**City of Glendale
Community Development Department
Design Review Staff Report – Multi-Family**

Meeting/Decision Date: October 11, 2021	Address: 3419 Montrose Avenue
Review Authority: ☐ DRB ☒ ADR ☐ HPC ☐ CC	APN: 5607-004-032
Case Number: PDR2106786	Applicant: Helbert Moradian
Prepared By: Danny Manasserian, Planning Associate	Owner: Arbita Nersesian

The applicant is proposing to construct additions at the front and rear of the existing house, build a new two-story residential unit and garages behind the house, and demolish the existing garage. The property is located in the R-3050 (Moderate Density Residential) zone.

PROPOSD SITE PLAN
1/8"=1'-0"

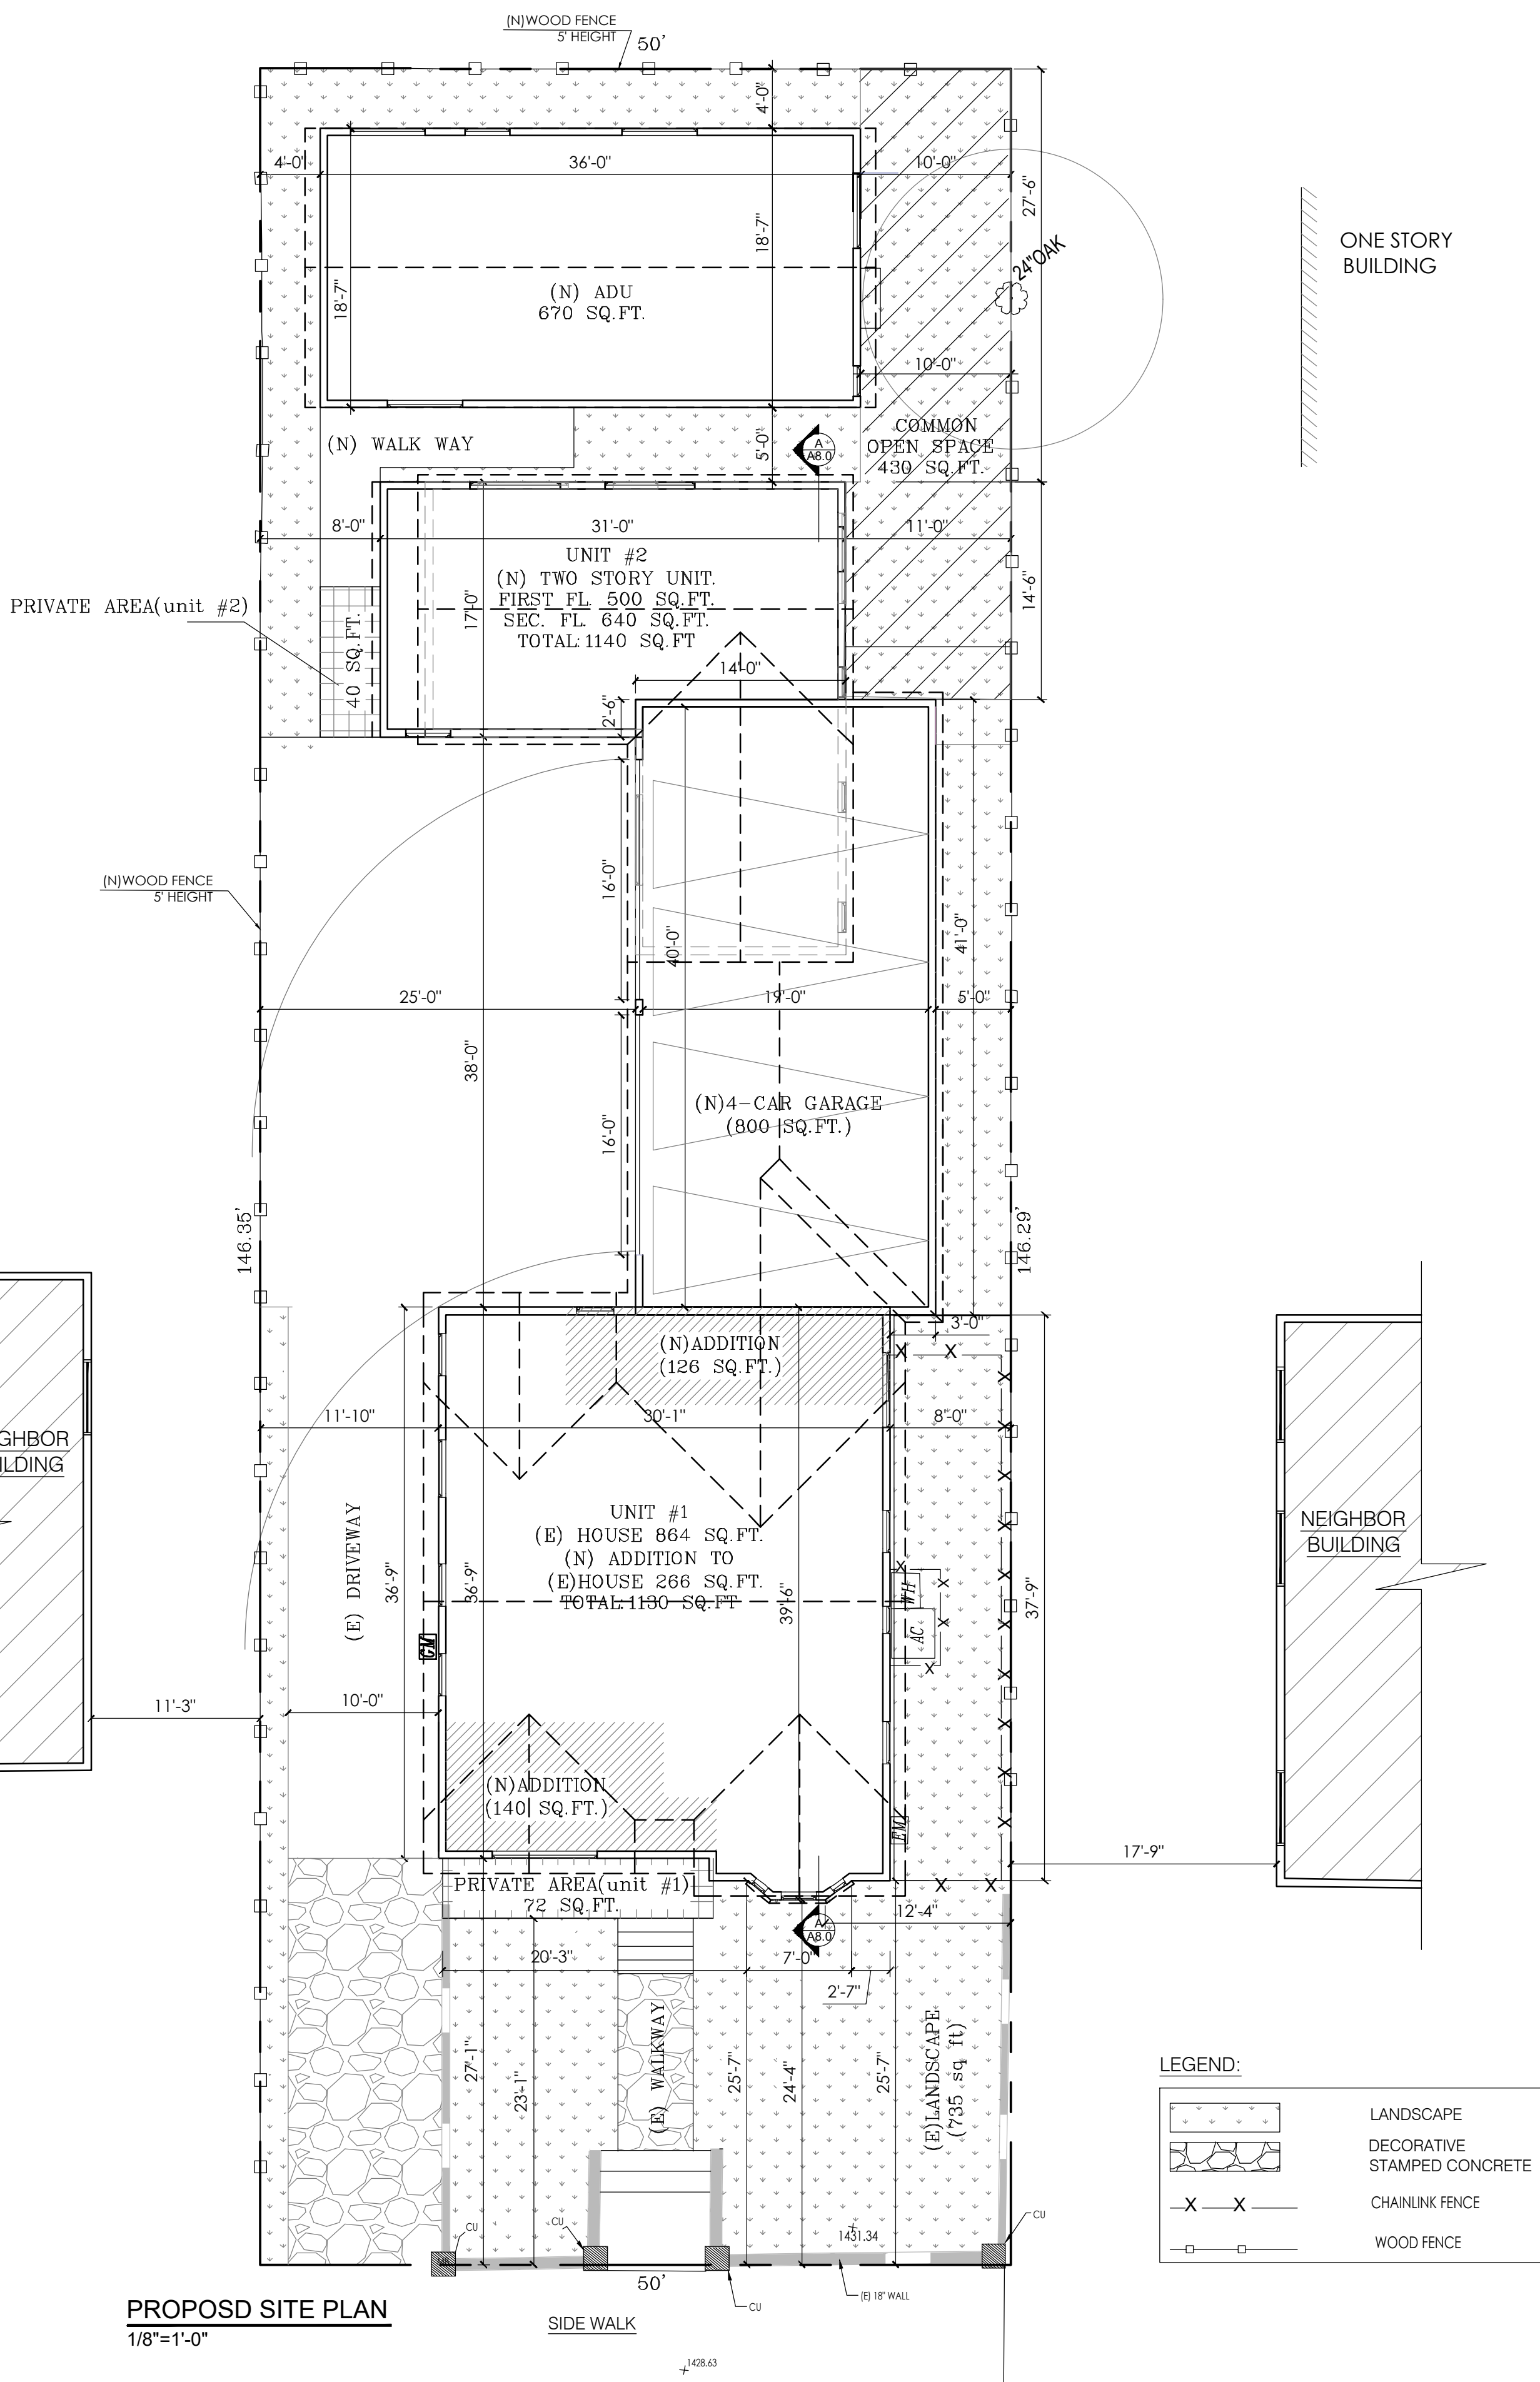
- The new two-story residential dwelling unit at the rear of the property will have an attached four-car garage. This garage will serve the new residential unit as well as the existing single-family house.

- The building footprint of the existing single-family house will change with the front addition bringing the west side of the house closer to Montrose Avenue (30'-9" existing setback to 27'-1" new street front setback). The existing 24'-4" setback at the east side will remain and the new footprint will not disrupt the prevailing setback pattern.

- The new residential unit and garage is designed with an L-shape building footprint, which is appropriately setback from all property lines to reflect existing neighborhood setbacks.

- Access to the new garage for the existing single-family house and new rear unit will be from the existing driveway located on the west side of the property, which is consistent with the existing site conditions and other properties in the neighborhood.

**UNIT
ELEVATIONS**

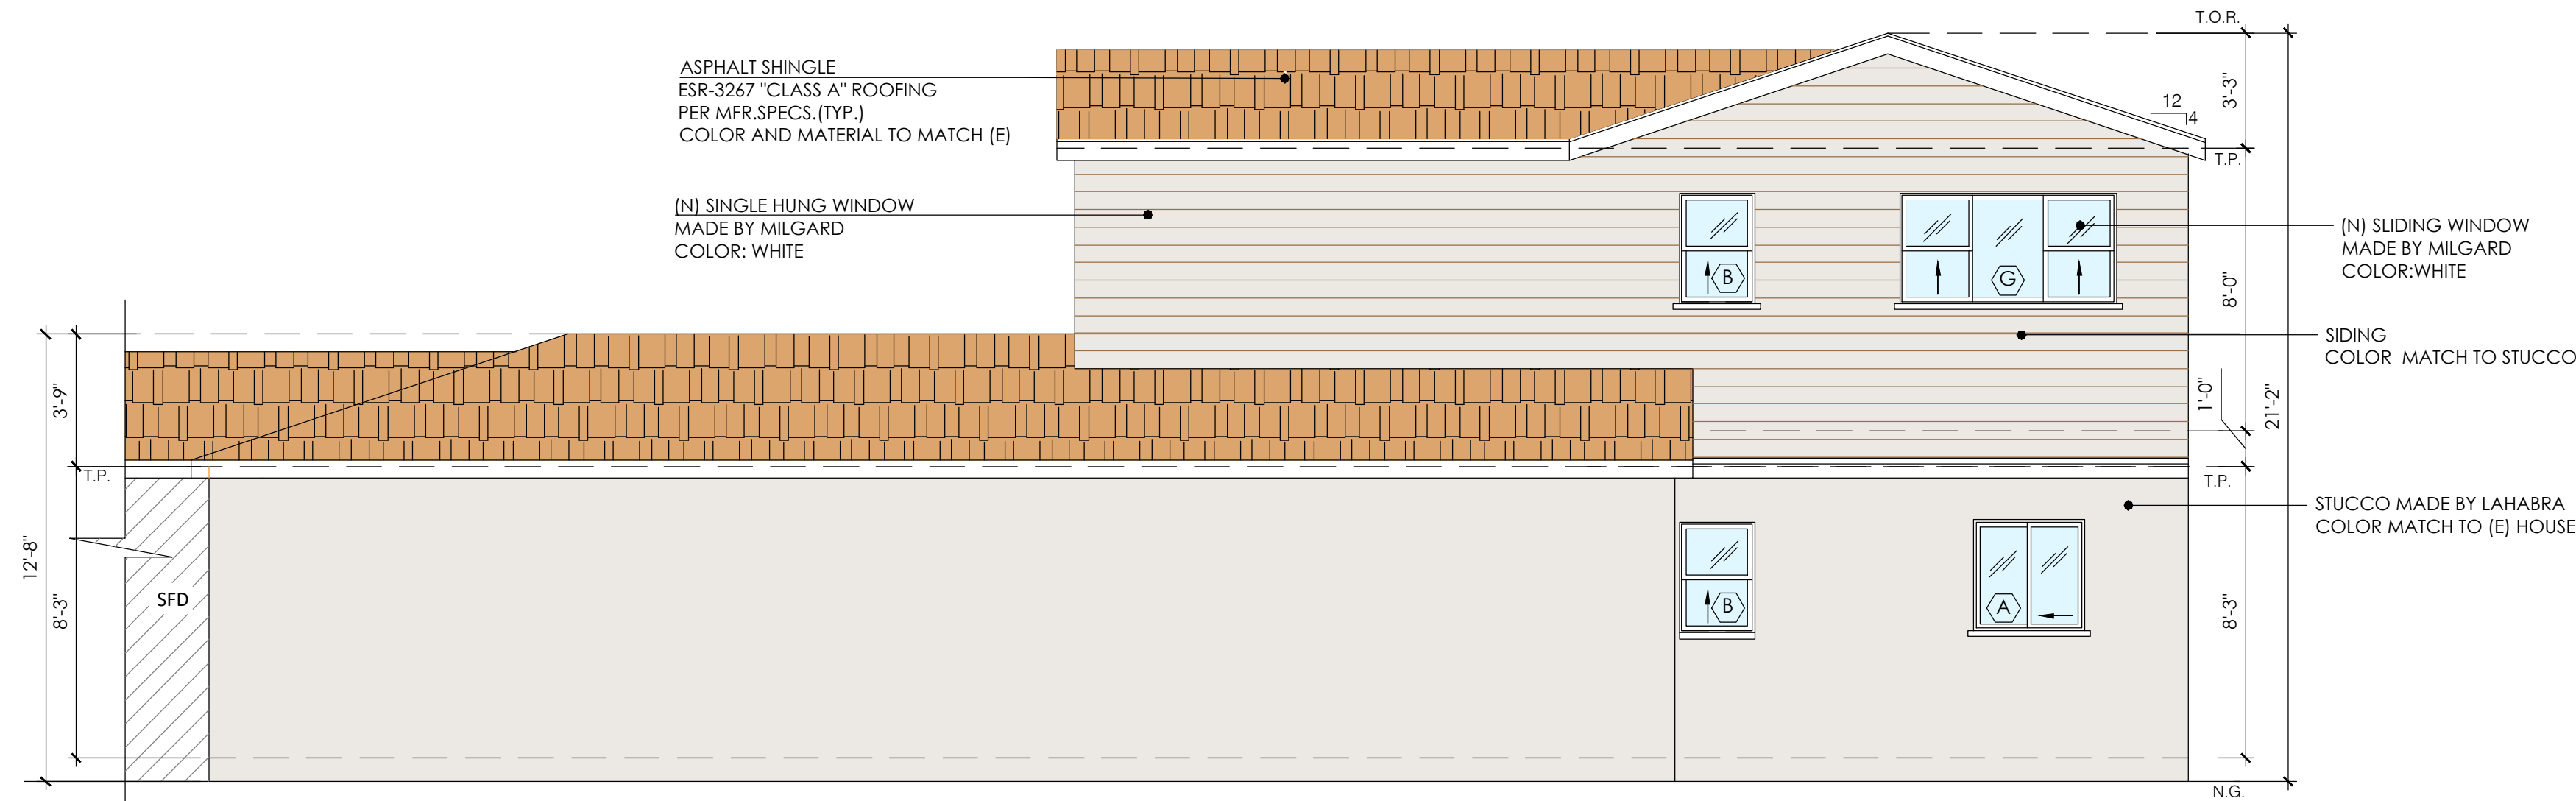
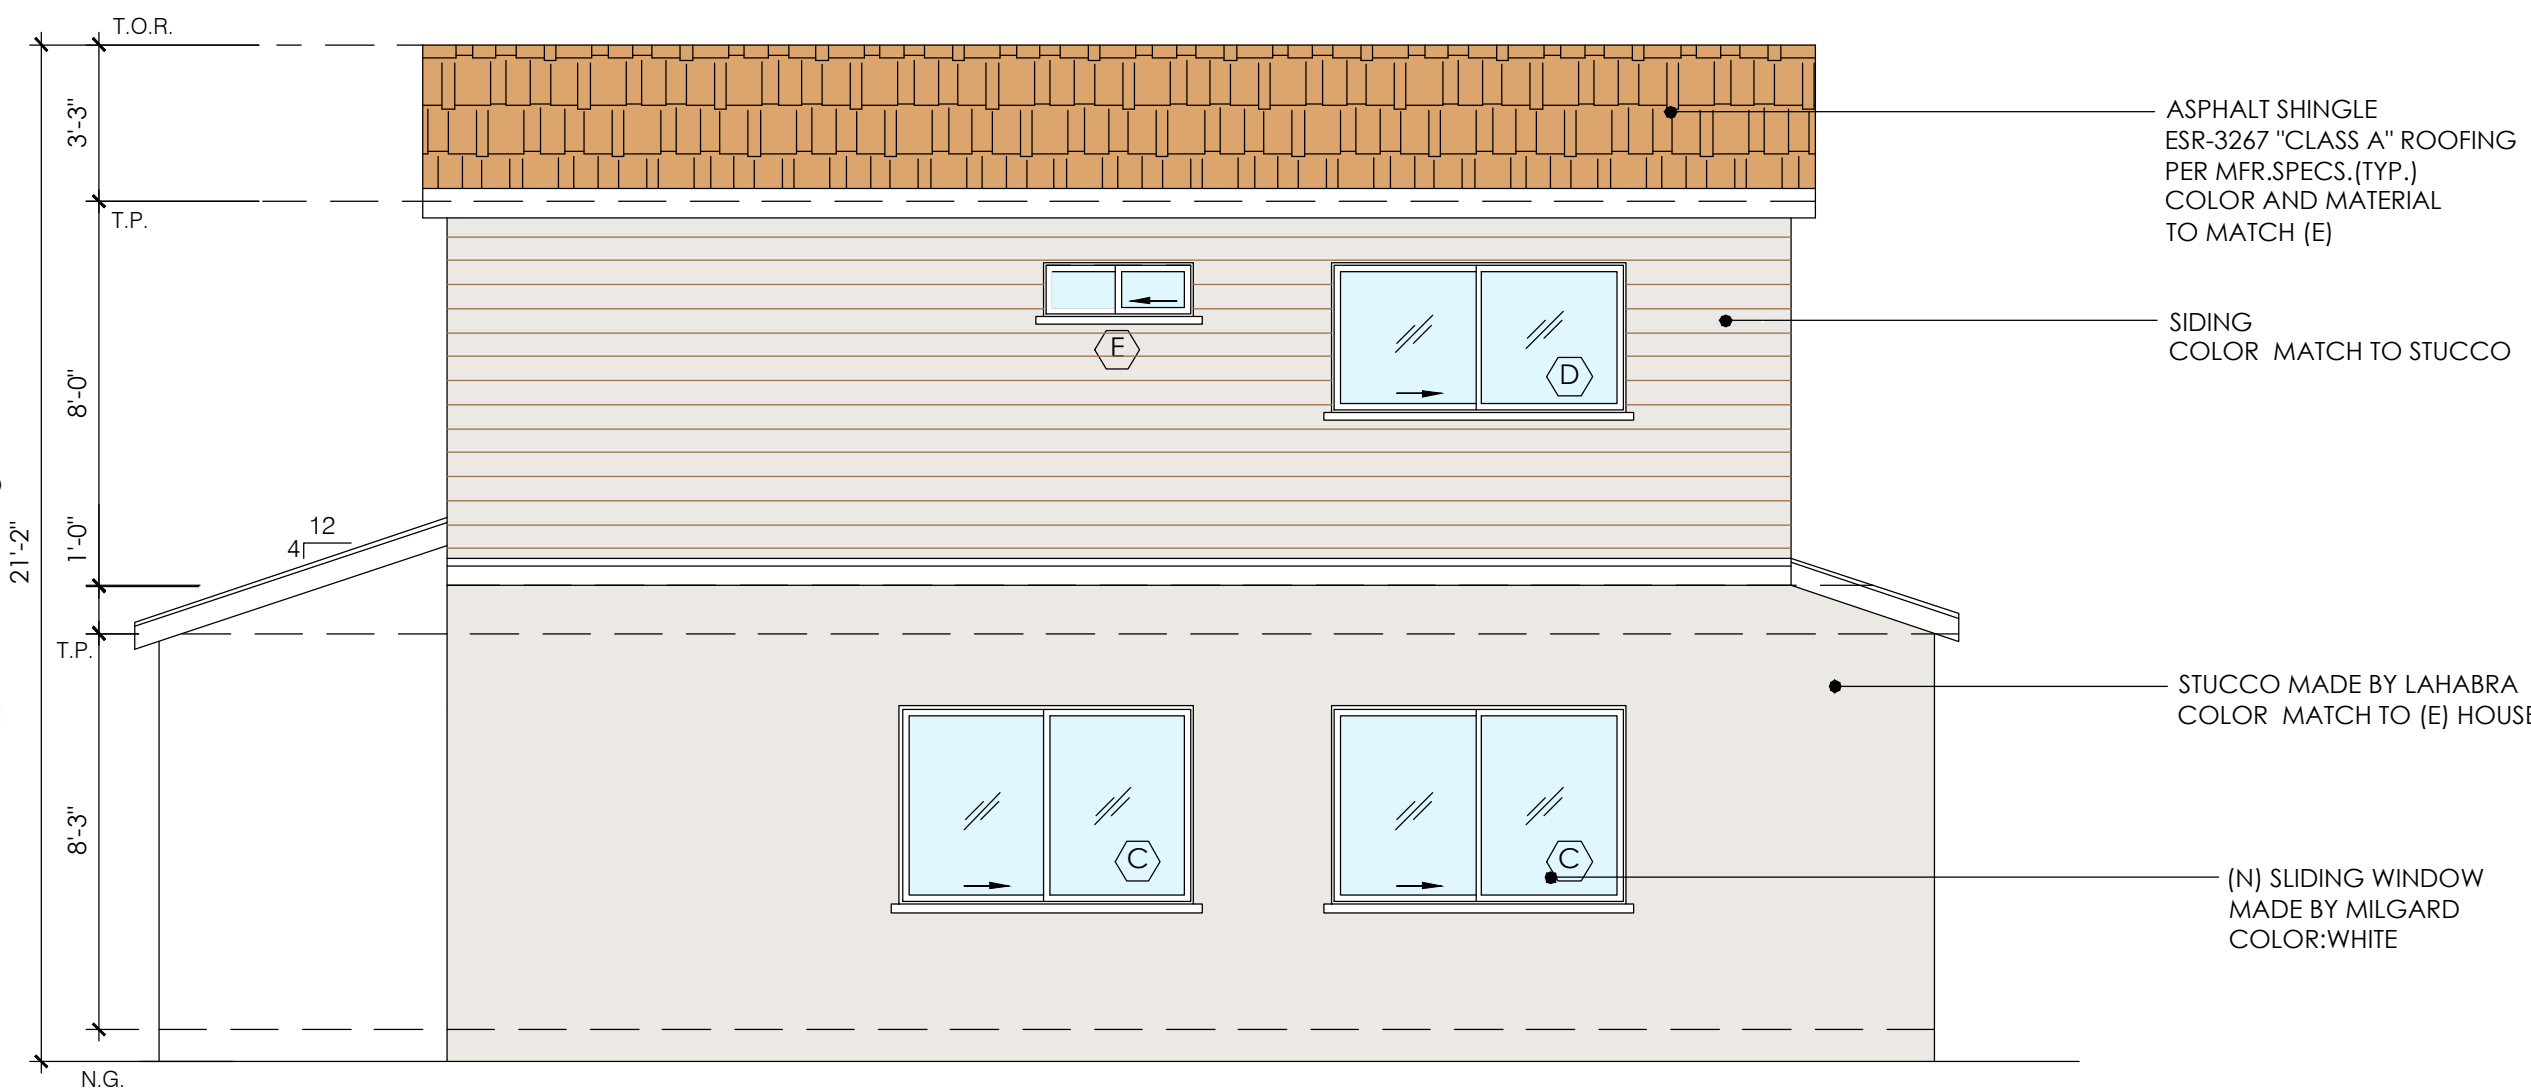
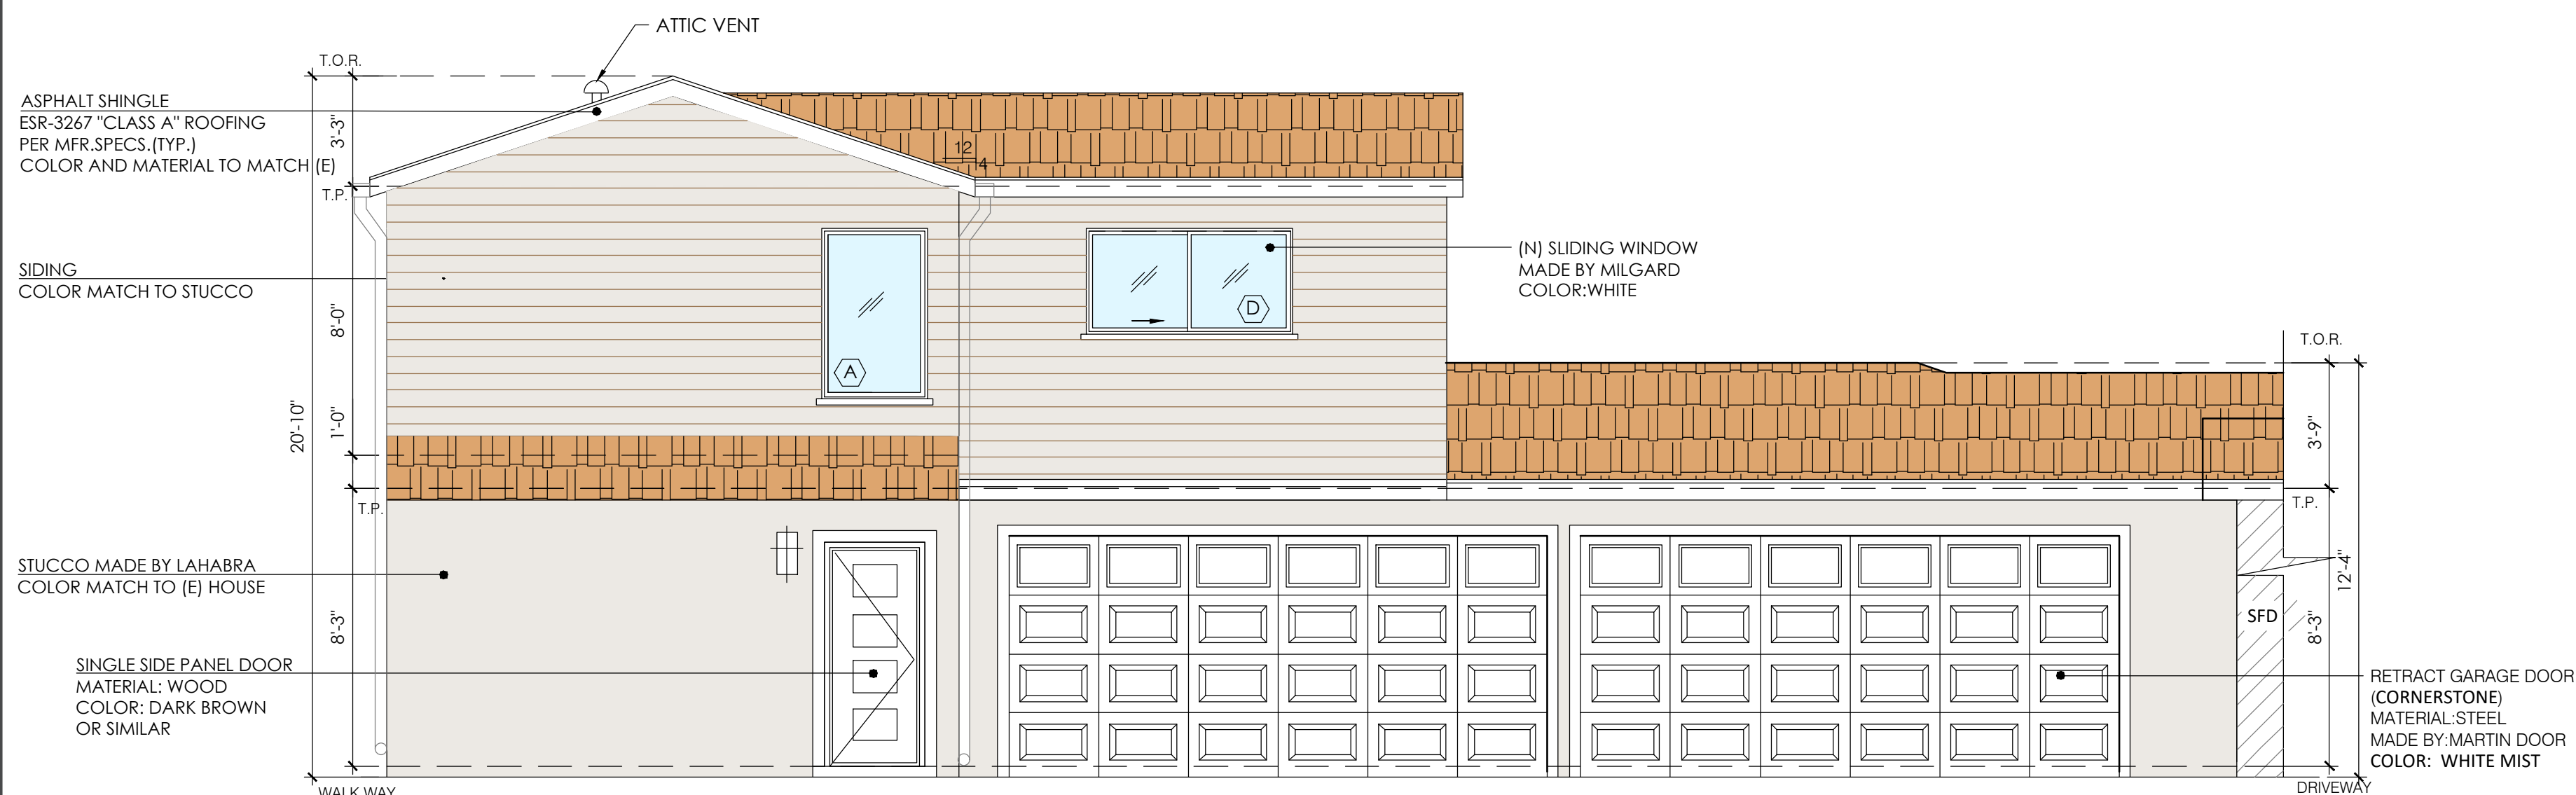
The design will be enhanced if the siding color is somewhat darker, rather than the same as, the color of the walls. A condition to this effect is added.

- The traditional design of the new unit is appropriate to the neighborhood and the existing house.
- The placement of the proposed cement fiber siding on the new unit is appropriate, however, as proposed, the color is the same as the stucco. A condition has been added to choose a somewhat darker color to complement the white stucco.
- All windows will be vinyl, recessed with a wood sill and frame to match the proposed windows on the front house. As proposed, the windows are appropriate to the design and the neighborhood in terms of their operation and overall appearance.
- The roof material includes brown composition shingle, matching the front house.

1. Propose somewhat darker color for cement fiber siding at new unit for staff review.
